STATE OF RHODE ISLAND AND PROVIDENCE PLANTATIONS  
ENERGY FACILITY SITING BOARD

IN RE: INVENERGY THERMAL DEVELOPMENT LLC's :  
APPLICATION TO CONSTRUCTION THE : DOCKET No. SB-2015-06  
CLEAR RIVER ENERGY CENTER IN :  
BURRILLVILLE, RHODE ISLAND :

**ADVISORY OPINION OF THE BURRILLVILLE PLANNING BOARD**  
**TO THE ENERGY FACILITY SITING BOARD**

Dated: August 31, 2016

Figure 1

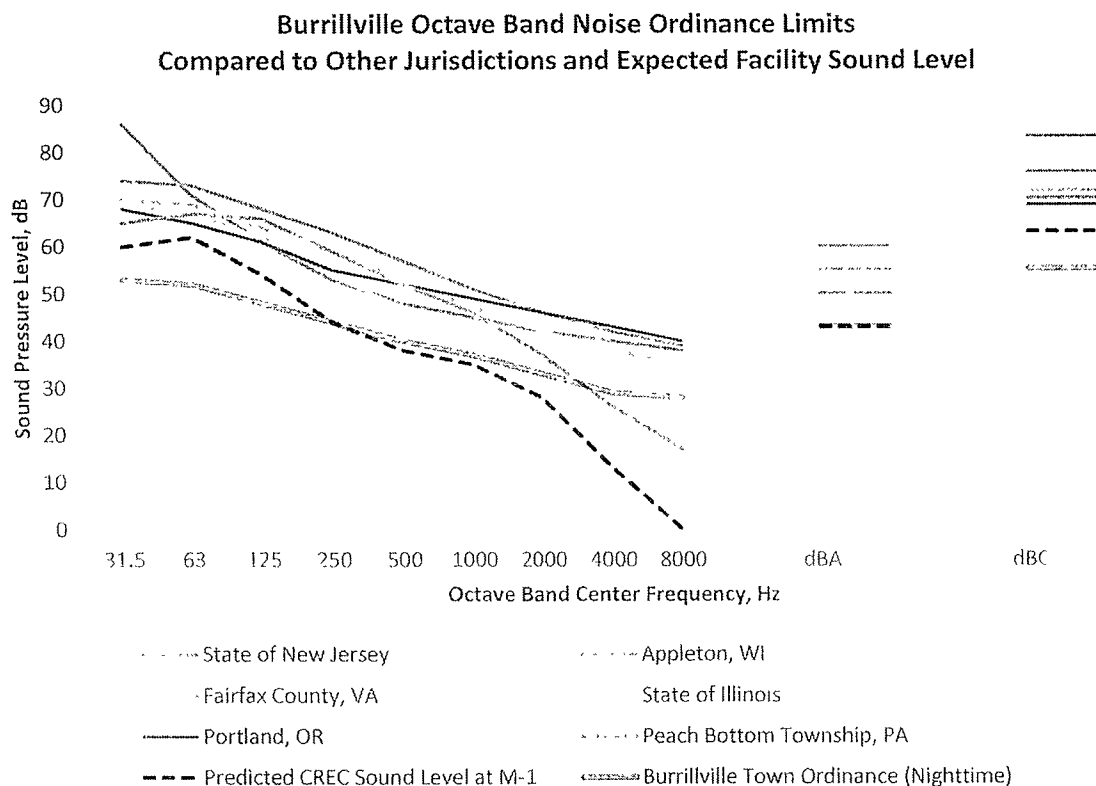
In addition to this it is important to realize that the octave band limits contained in the Town Ordinance, especially in the lower frequencies, are well below all the other octave band regulatory limits that we're familiar with. The chart below shows a series of nighttime octave band noise limits from a variety of jurisdictions compared to the Town's limits (thick red line).

This graphic shows that the Town's limits are well below what might be considered the norm, but, more to the point, there is no actual need for the limits to be this low. The expected plant sound level at the closest residences is shown as the blue dotted line. Although it's not intuitively obvious, the plant would not be any less audible or sound any quieter if its sound levels in the three lowest octave bands were equivalent to the Ordinance rather than over the limits as currently predicted because, in a nutshell, the human ear is not very sensitive to frequencies below about 200 Hz, so the facility would effectively sound the same either way. In fact, subjective audibility is basically quantified by the overall A-weighted sound level and both the Ordinance spectrum and the plant sound spectrum in the chart both total up to 43 dBA, indicating that the sounds are of the same subjective magnitude. This overall limit of 43 dBA fully serves the purpose of limiting the project's noise to an acceptable level in the community. Invenergy has repeatedly argued that it is not feasible to meet the lower octave band limits and they have asked for a waiver on the octave band requirements. This is a legitimate assertion and a legitimate request. We would agree that it is probably technically impractical - and would add that it would do nothing to reduce the subjective audibility of the plant if it were.

Figure 2 Typical ACC Steam Duct

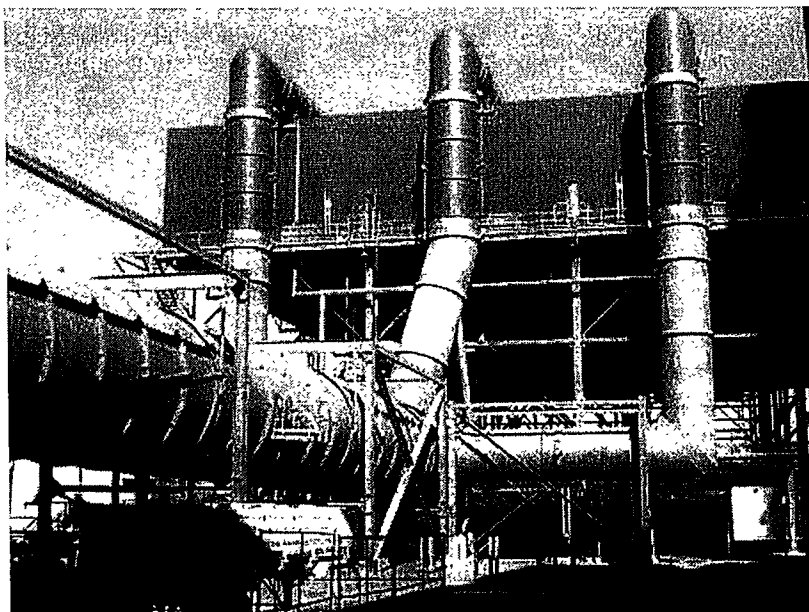
Consequently, while not all that unusual, we would fault the Applicant for avoiding any mention of start-up noise in their initial noise study for the important reason that the plant will employ air cooled condensers (ACC's). In our experience, ACC's are particularly prone to extremely high noise levels during start-up because very high pressure steam, not yet suitable for introduction into the steam turbine, is bypassed directly into a cavernous duct leading to the condenser (Figure 2). Because this duct is maintained at less than atmospheric pressure by vacuum pumps and noise generation over a valve is largely proportional to the pressure differential, it is quite difficult to keep this process, essentially a continuous explosion, quiet, even with "low noise" valves.

To their credit, when queried about this issue through the data request process, Invenergy did the right thing and commissioned an additional, detailed noise modeling study to evaluate the sound emissions from the facility specifically during start-up and steam turbine bypass. We have reviewed this new study and consider it competently done; however, the model inputs representing noise from steam turbine bypass into the condenser duct appear to be rather optimistic and much

**Figure 1** ACC Steam Duct Enclosure Under Construction

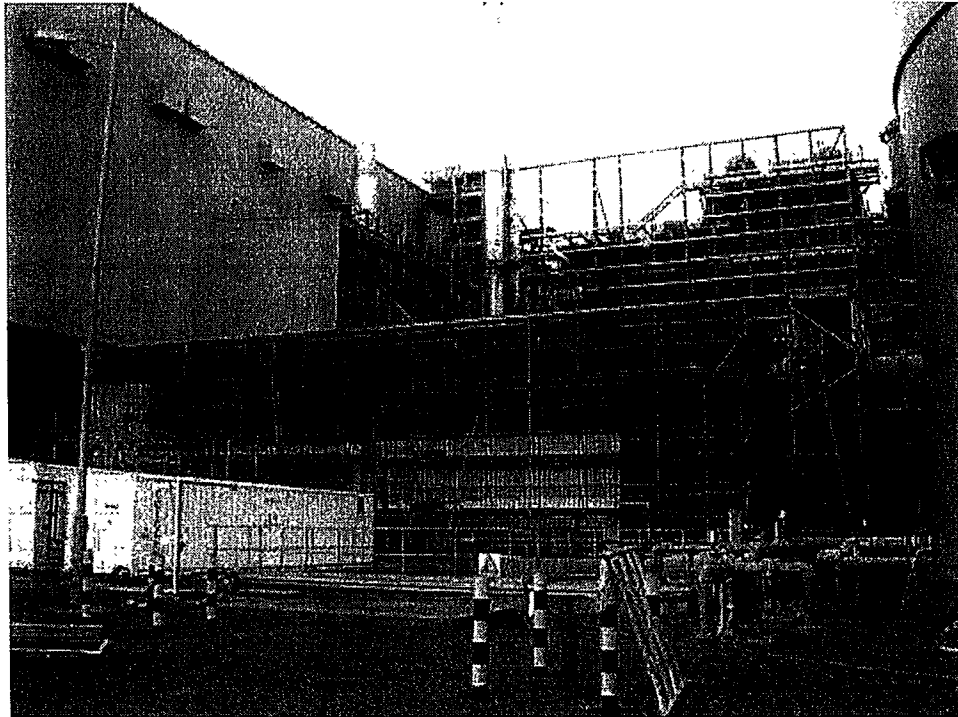
If a field test is impractical then I would ignore the guarantee and assume that the steam duct sound level will be in the 95 to 100 dBA range during bypass (based on past first-hand measurements of ducts using CCI low noise valves). The mitigation required for such a situation would probably involve a free-standing rigid enclosure over the initial (Figure 1) or entire horizontal run and lagging on the vertical risers. However, the appropriate amount of attenuation for each section or component must be calculated through analytical modeling.

If field testing or design assumptions suggest an enclosure, it should be built along with the rest of the plant and not held back as a potential retrofit, since that would create a period during which start-up noise would presumably be non-compliant.
